# **HYDROLOGY REPORT FOR AREA 2 @ SOMERSETT**

RE: Area 2 Phase 1 (LDC03-00401)

Date: March 28, 2003  
To: Vern Kloos, AICP, Interim Planning Manager  
From: Keith Lockard, P.E., Senior Civil Engineer *see [signature]*  
Through: Robert M. Gottsacker, P.E., Engineering Manager, Development Services Division  
Subject: Application Review

LDC03-00401 (Somerset Area 2, Phase 1) – A request for: (1) a tentative map for 72 single family homes; and (2) a special use permit for cuts over 20 feet and fills over 10 feet. The project site is located at the terminus of Evening Rock Trail in Willow Ranch in a PUD zone.

**PLATE 1**  
**STORM DRAINAGE**  
**SOMERSETT**  
**AREA 2**  
 Washoe County Nevada

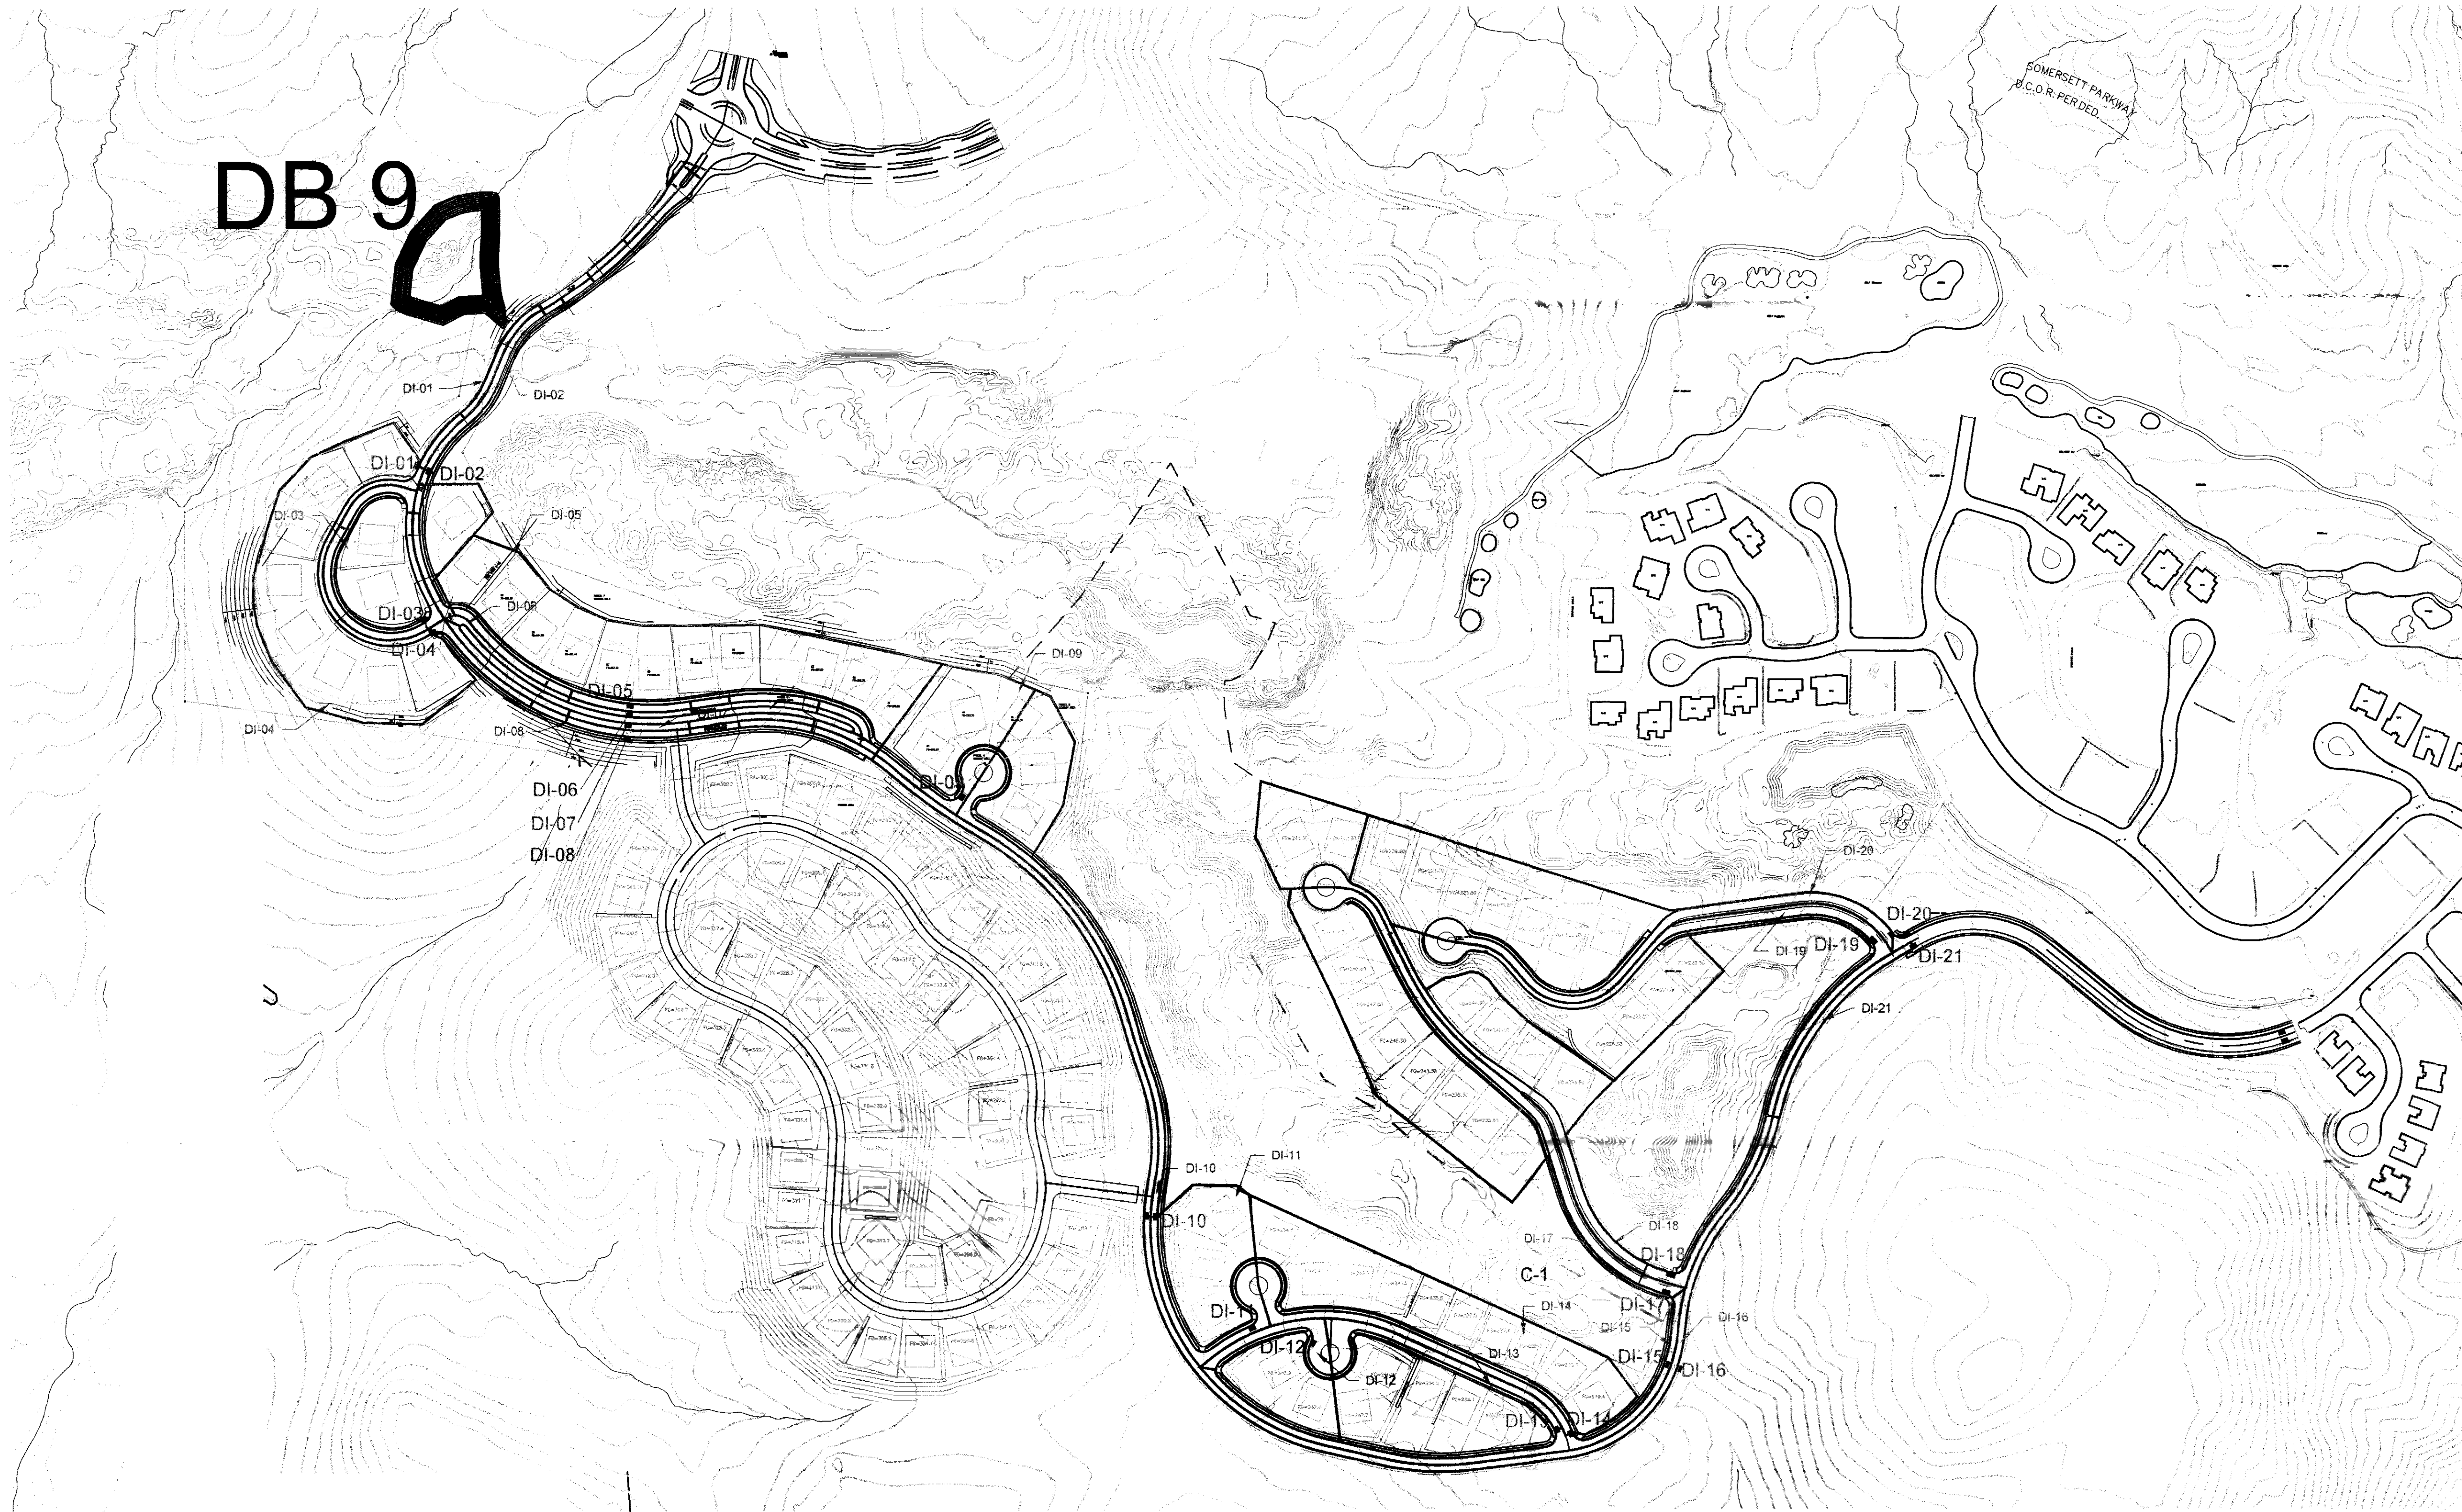
Hole 9 golf course drainage appears to sheet into streets and lots on sheet C-10. Please account for this in cut-off swales or drainage easements and ditches/pipes.

- 5) Old#8 The sidewalk along Charlie is extended the full length of the roadway and is shown on sheet C-11.
- 6) Old#9 The drainage is picked up in a swale within the golf course and discharges into a ditch behind lots 24, 25. The ditch conveys flows to a crossing with Evening Rock Trail. Ref. the revised hydro report.

*change drainage report clarify maintenance of golf structures* (9.)
